THE APPLICATION OF WOOD CREEK WATER DISTRICT, OF LAUREL COUNTY, KENTUCKY, FOR APPROVAL OF CONSTRUCTION, FINANCING AND INCREASED WATER RATES	))))	CASE NO. 9594

Report on the Feasibility of the Construction of a 20-inch Water Line for the Wood Creek Water District Case No. 9594

CURVE

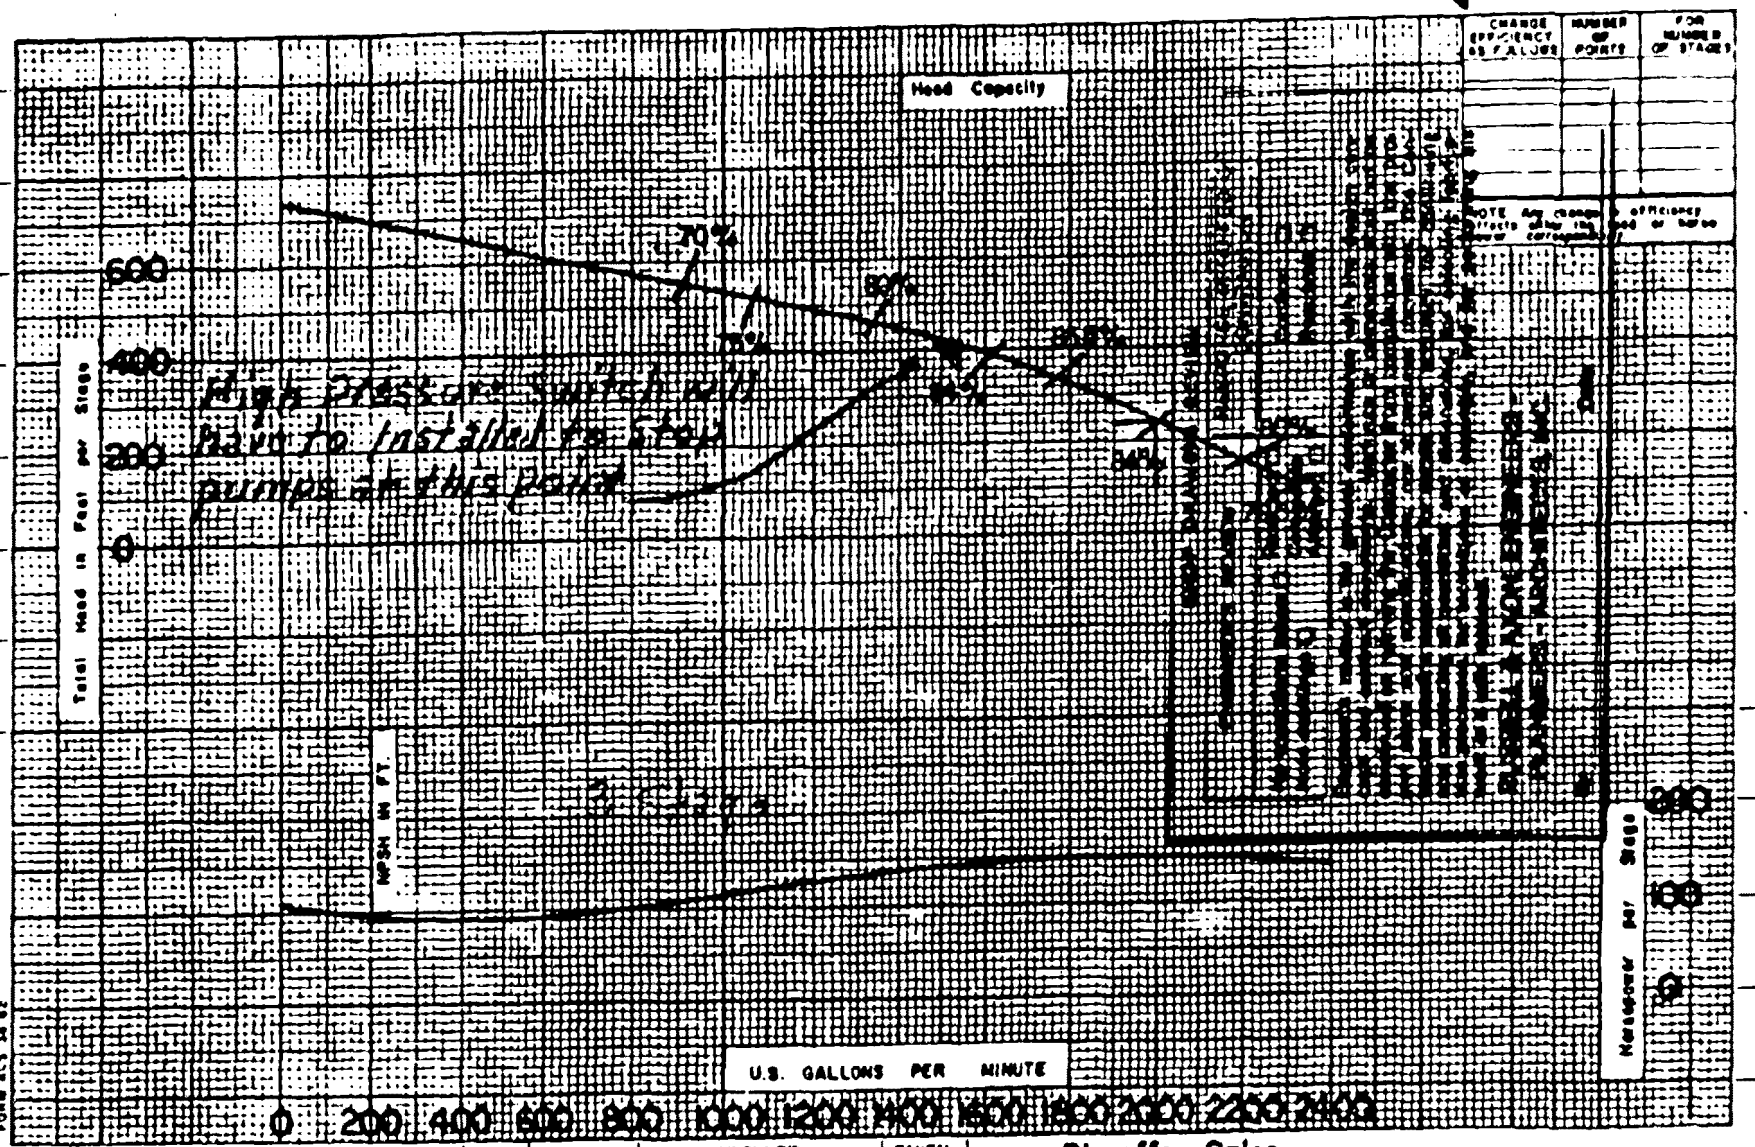
The existing high service pump was sized to pump approximately 2,000 gallons per minute (gpm) at 240 feet Total Dynamic Head. The characteristic (head vs. gpm) pump curve for the existing high service pump is attached. The pump curve indicates the operating points at which this particular pump can operate. In general, operation at or near the left hand side of the characteristic curve is inefficient. Operation at or near the right hand side of the characteristic curve is inefficient and can

lead to damaging cavitation of the pump. The most efficient operating points are generally in the mid-range of the pump curve. Any centrifugal pump will operate on its characteristic curve at the point dictated by the system head curve. Selection of a pump should be made allowing for varying operating conditions so the pump will operate under actual conditions at or near the most efficient operating points.

While Wood Creek intends to replace the existing pumps in the future, under the present proposal only the 20-inch water line is to be installed now. The 20-inch line will reduce the system head to the extent that the existing high service pump will "cavitate" or "spin-out". In order to make the existing pump operate, head will have to be artificially induced to bring the system head curve back up on the pump characteristic curve. This could be easily done by partially closing a valve on the discharge side of the pump -- a process generally called "throttling". This is an inefficient means of operation and in essence would make the system operate as if the 20-inch pipeline had not been constructed at all. In fact, Wood Creek states in its answer to the Commission's September 11, 1986, information request that it "will not specifically and directly benefit from the proposed improvements" until the water demand from the adjacent water districts increases.

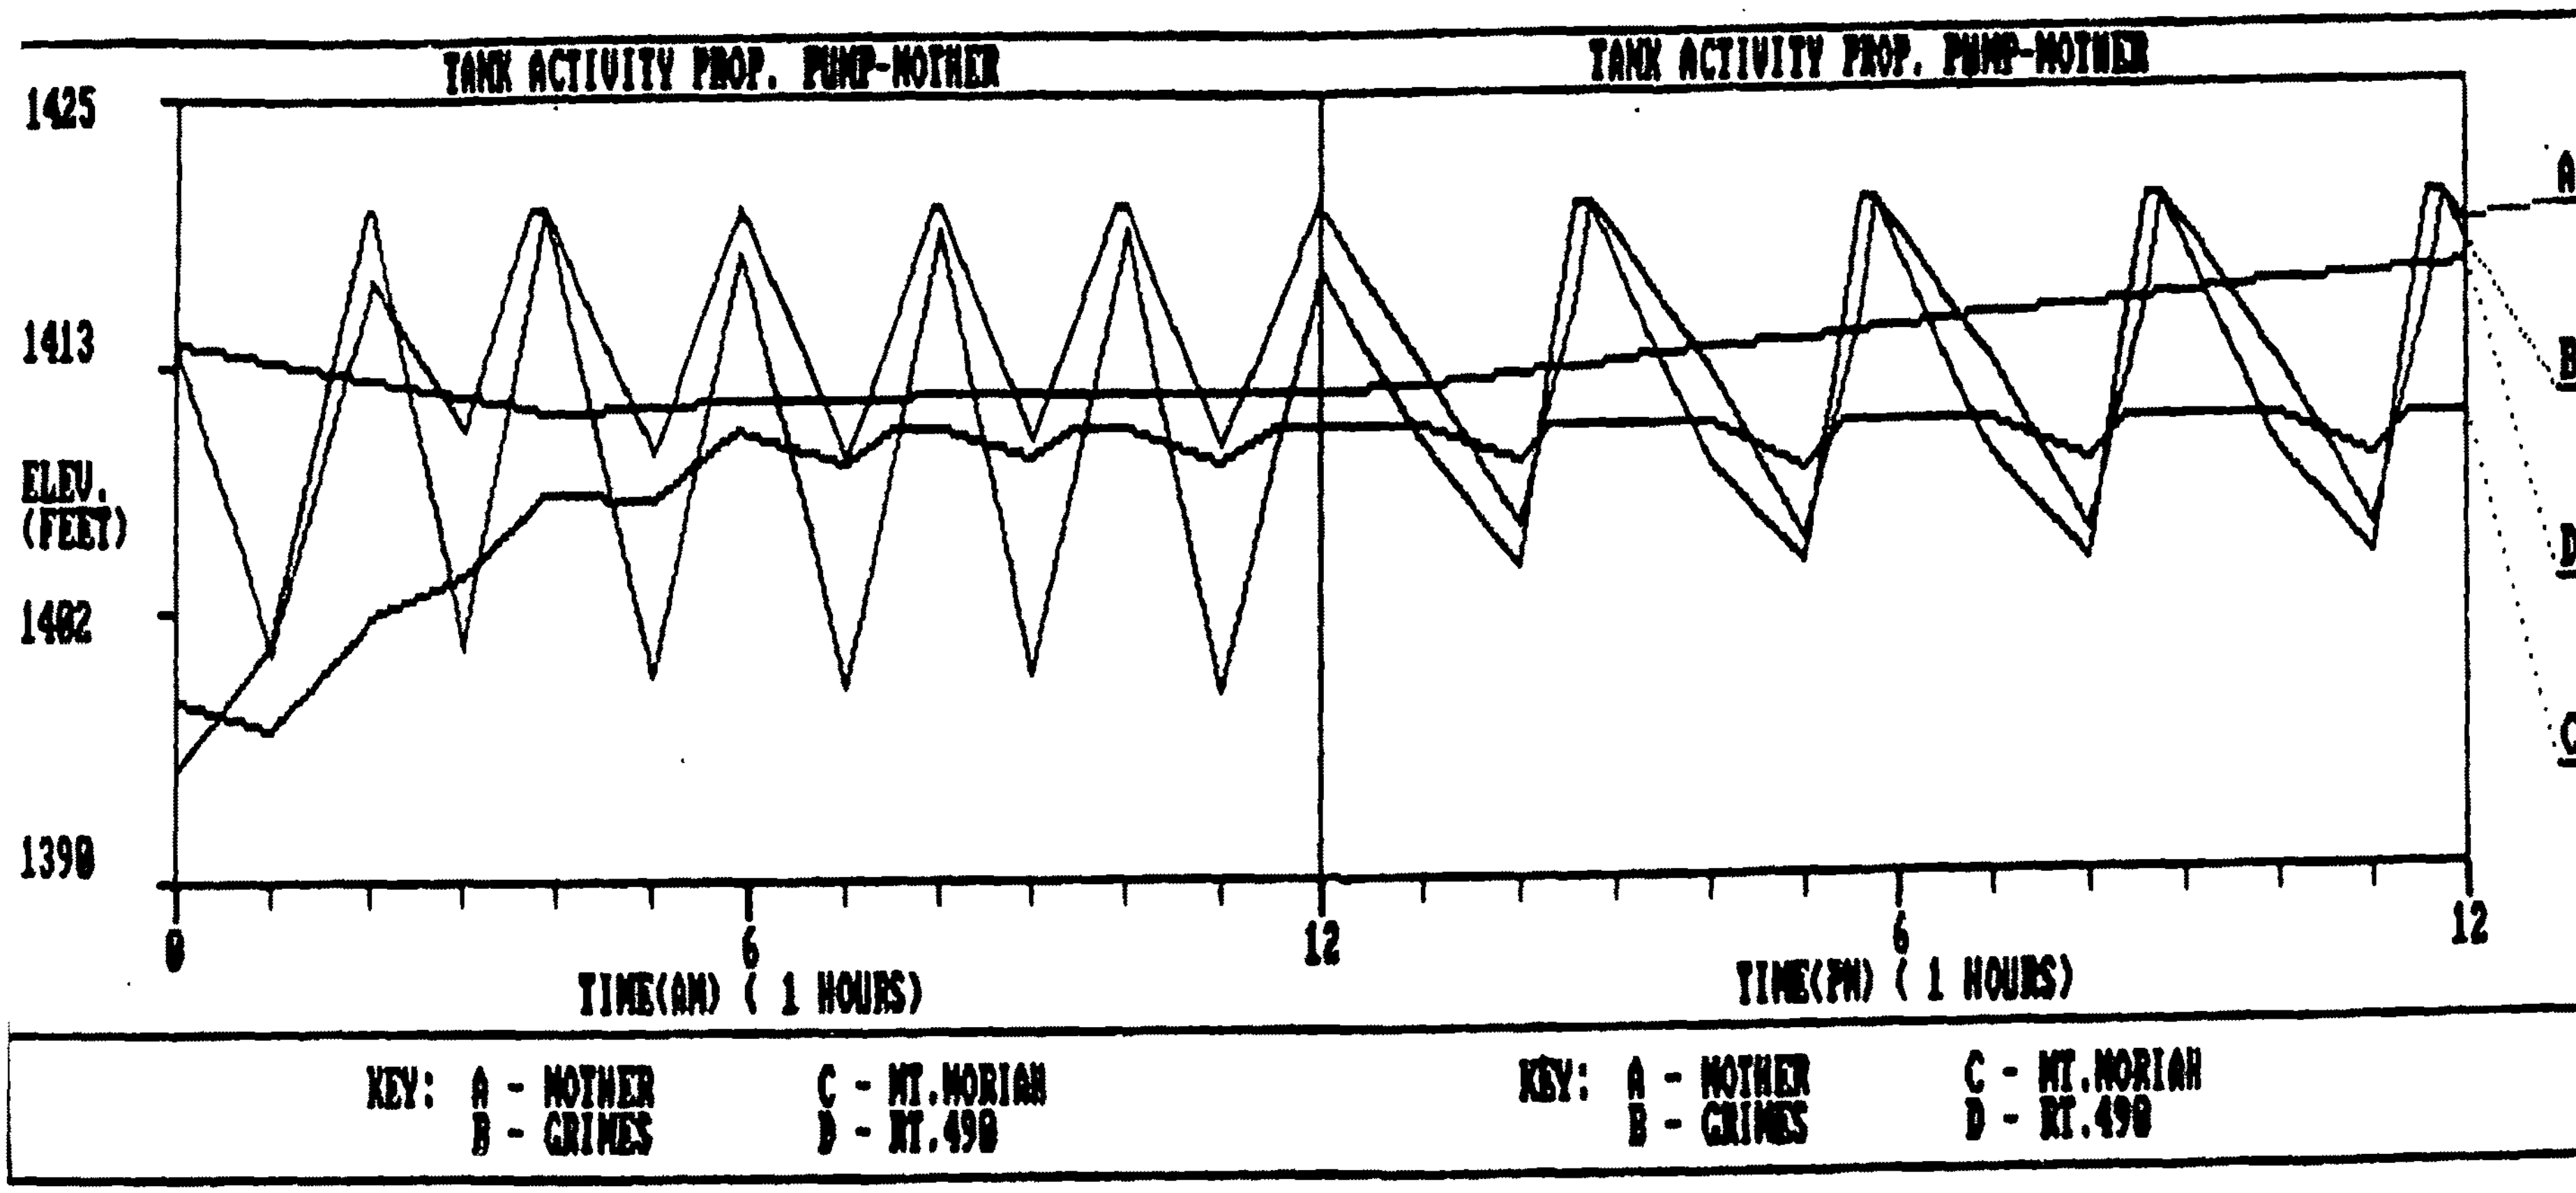
The next question to be asked is if this line is installed, when could some benefit be realized. It is assumed that Wood Creek's filing of a hydraulic analysis with a 4,000 gpm high service pump is to indicate the operation of the system after the water treatment plant is expanded. While this analysis indicates the ability to pump more water, the operation of the system does not appear to be improved. As can be seen from the attached graphs, the "on/off" cycle of the high service pumps has been significantly altered and the tank levels are subject to constant variation. (NOTE: The attached graphs depict the results of computer hydraulic analyses performed by Public Service Commission engineering staff. The computer runs were based on the data filed by Wood Creek.) Another problem with the hydraulic analysis is that it depicts the system with an expanded treatment plant and the installation of the 20-inch line but with current demands. This takes us back to one of our initial concerns - when and where is the demand expected to increase. Should the demand not significantly increase after the treatment plant expansion and the installation of the 20-inch line, operation of the system will not be significantly improved.
